### AGENDA PACKET

### **DECEMBER 19, 2023 MEETING**

Re: Application of The Wolf Conservation Center, Inc., for Subdivision, Site Plan, Special Permit Approval, Wetland Permit and Stormwater Permit in Connection with a Private Nature Preserve on Property Located on Buck Run, South Salem.

EROSION CONTROL PLAN, 11/22/2023 12:06:59 PM

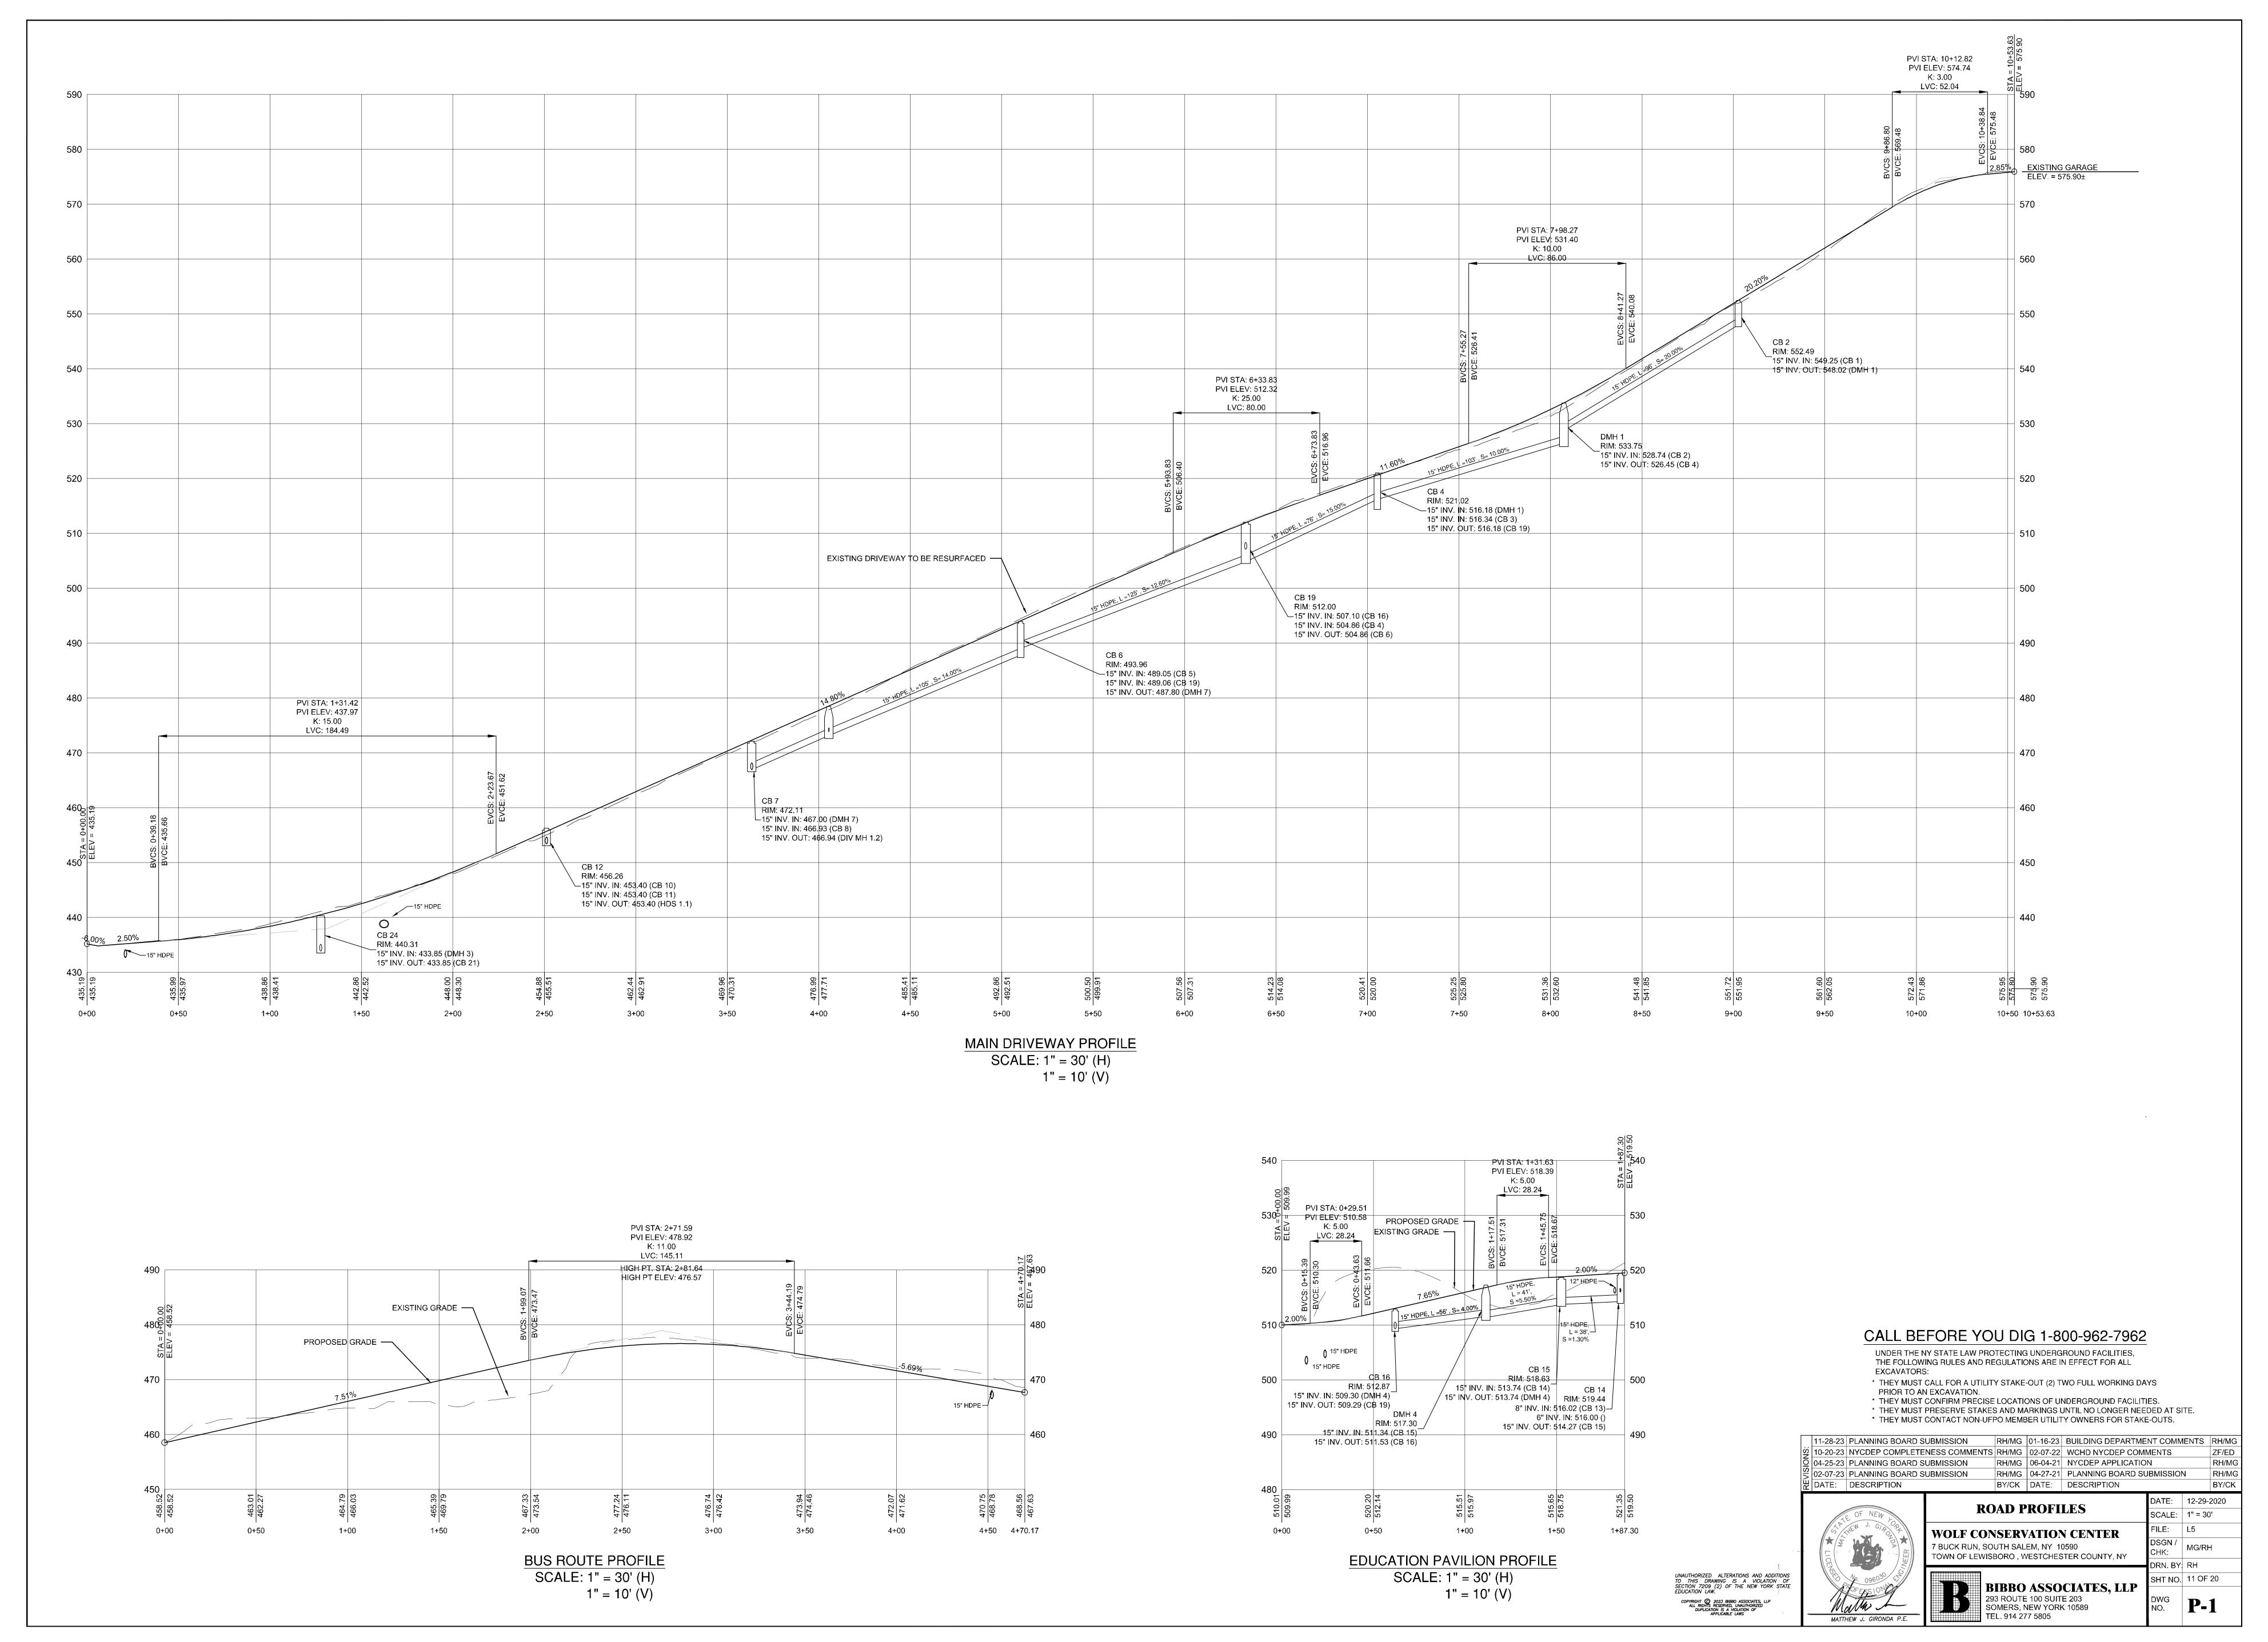
7. Comment: As previously noted, we continue to recommend the need for diversion swales and water bars to be utilized during construction. The practices as shown and described in the SWPPP will only function once the conveyances have been installed. It is recommended that temporary sediment traps be constructed during construction. A second temporary sediment trap may be required at the upper portion of the development. Provide adequate sizing calculations in accordance with the NYSDEC Stormwater Management Design Manual (SMDM). Alot of the disturbance will be located on steep slopes, which will affect the downgraded portions of the project. Furthermore, a phasing plan should be implemented which outlines the phases of construction noted in the construction sequencing notes.

Response: The erosion control plans have been revised to include additional erosion and sediment control measures in the form of water bars, temporary stone check dams and a double row of silt fence which has been added immediately downgradient of critical areas. As the Applicant's consultants continue to coordinate with NYCDEP on the SWPPP, they will explore the possibility of utilizing an infiltration basin as a temporary sediment basin during construction.

# **INFILTRATION BASIN OUTLET CONTROL CONFIGURATION**

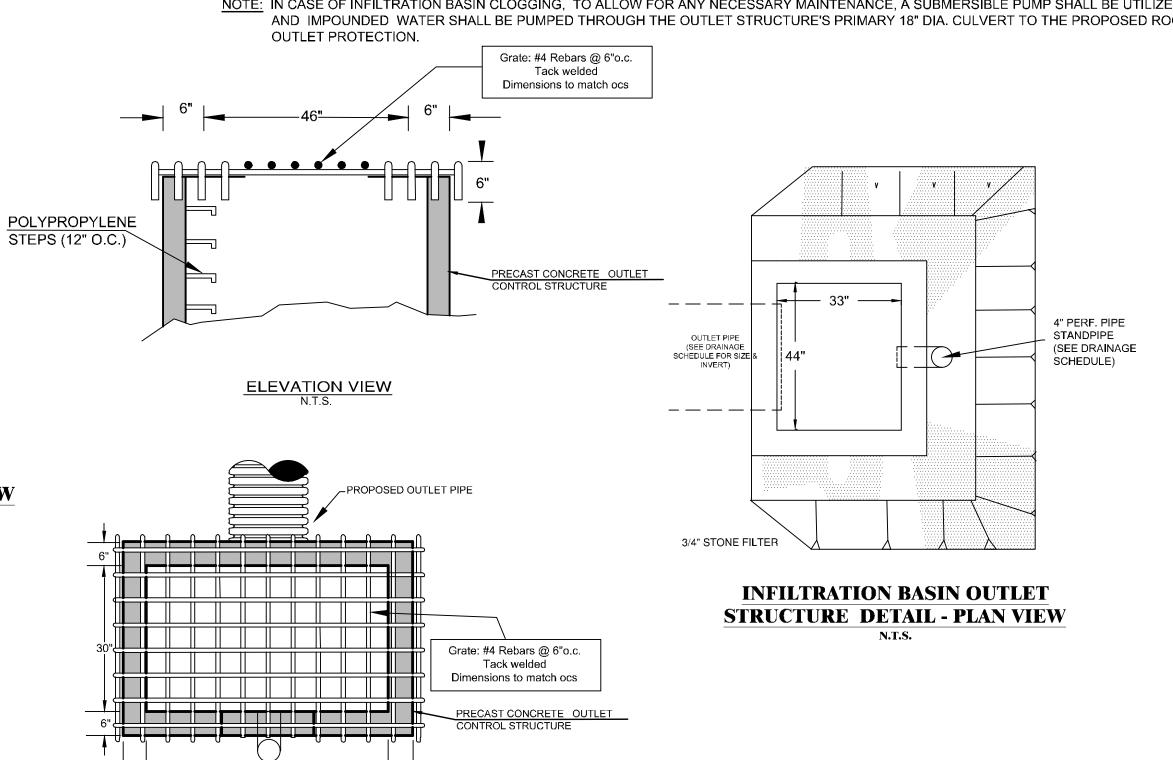
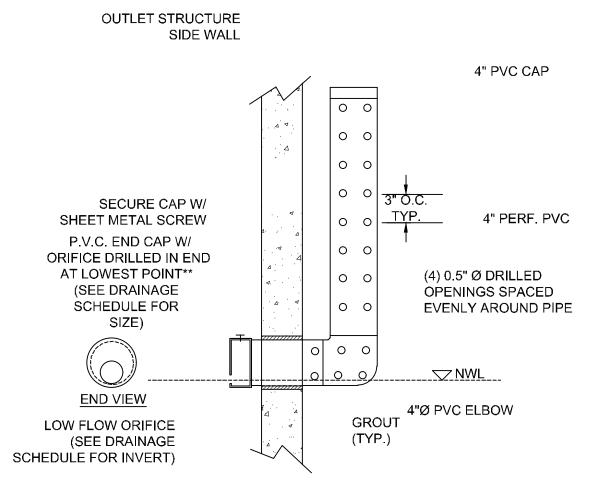
4. Comment: Please provide a detail for Proposed Outlet Structure #1.1.

Response: A detail for the proposed Infiltration Basin 1.1P outlet structure is included on Sheet D-2 of the enclosed drawings.

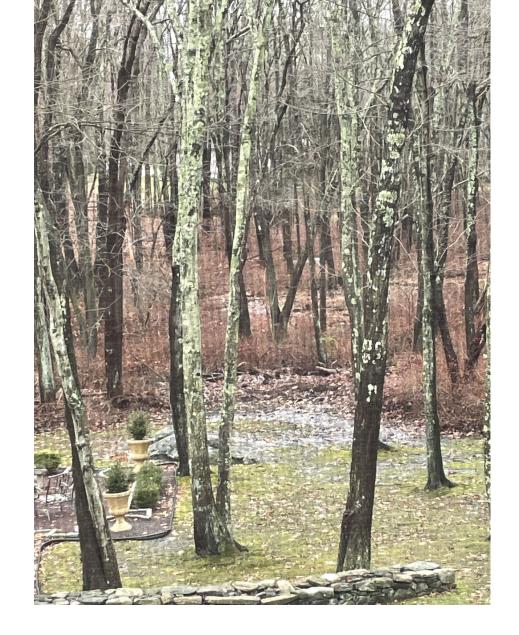
Please see the photos below taken from the second floor of our home, that show at least two large "ponding areas" on the vacant lot - the property line is right where our lawn ends. This was just from Wednesday's rain.

Also note how these ponding areas are closer to Post Office Road than the stream and wetlands, directly where the proposed new house would be built. You can see the stream and Post Office Road in the photos.
